21 storey commercial office building with associated commercial tenancy, loading dock and bicycle parking

52-56 Franklin Street, Adelaide

020/A023/18

ASSESSMENT REPORT

GROUND FLOOR PLAN

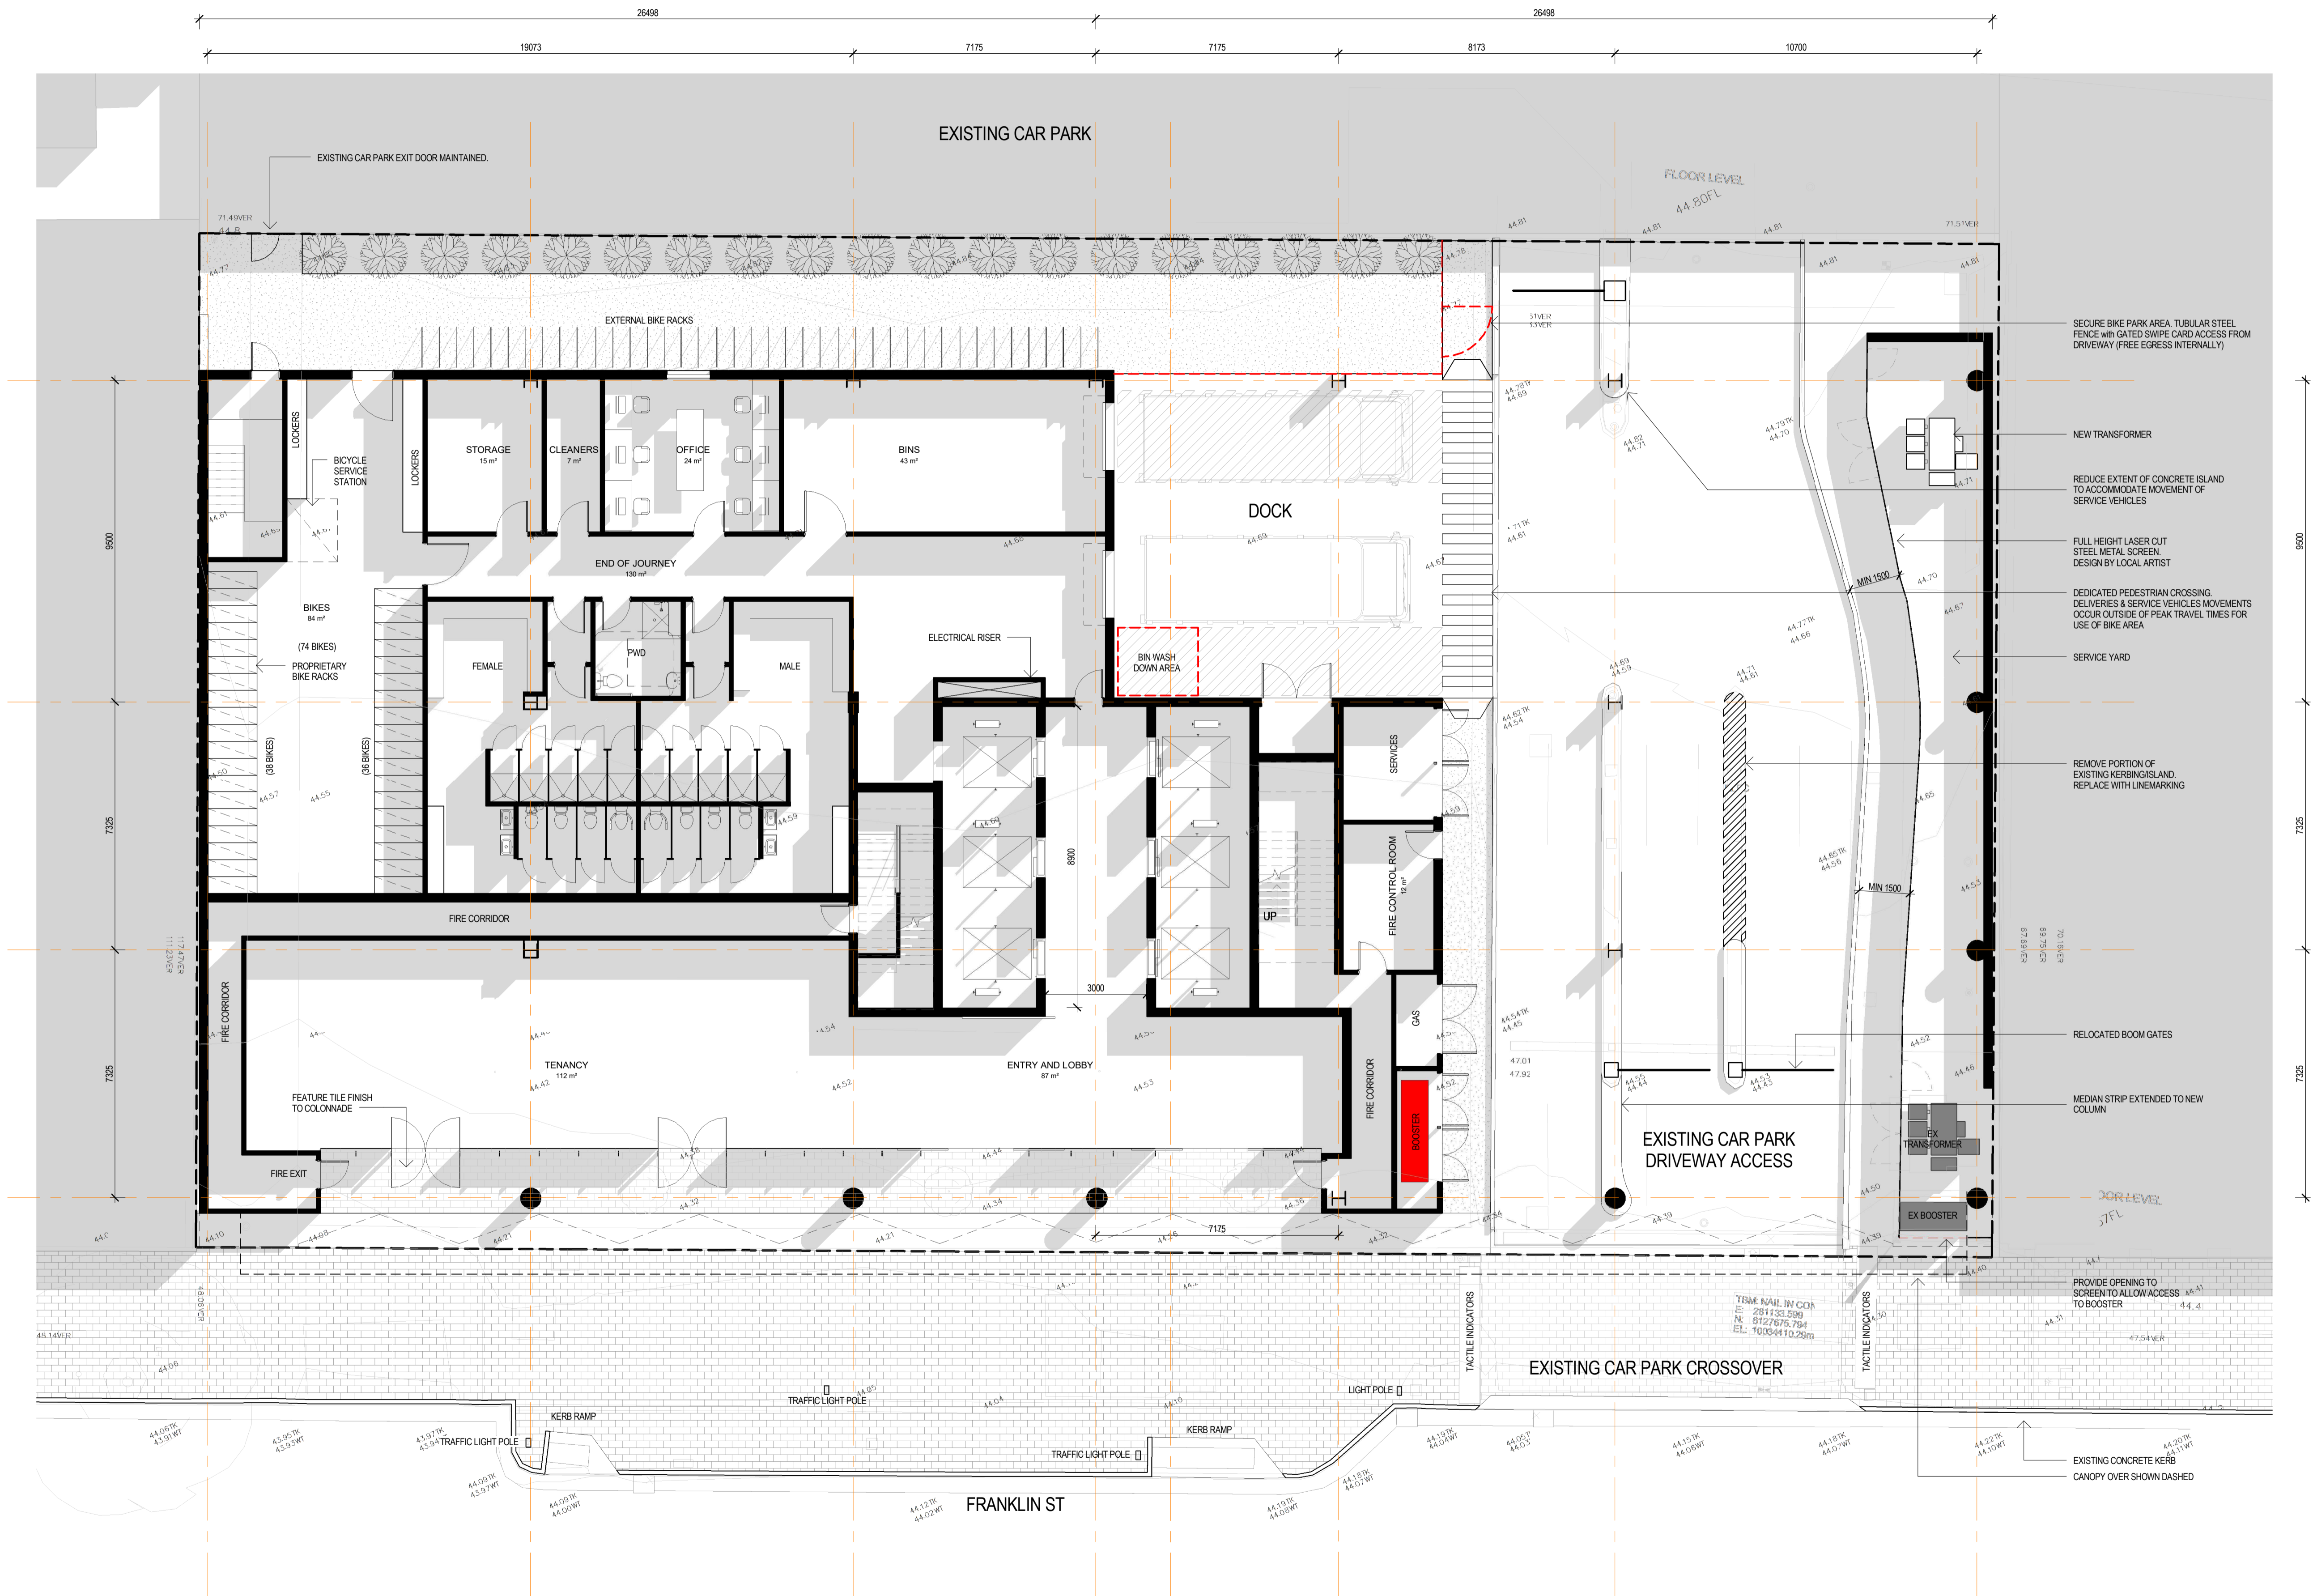
A new transformer was repositioned to the site's north east corner enabling modification of the eastern footpath to prevent obstructions to service vehicle movements and provide a minimum 1.5 metre-width as recommended by Council, along with delineation of the pedestrian priority crossing of the loading dock adjacent the western footpath as discussed earlier. Other precautionary treatments would be provided to address Council recommendations including protection of structural columns by median islands and direction signage.

The AGA recommended review of the end-of-trip facilities to provide clear and convenient access, which the applicant has addressed through pedestrian safety improvements adjacent the driveways and addition of a secure gated enclosure for the external storage area. This is considered an acceptable solution given the preference for active edges along the Franklin Street frontage.
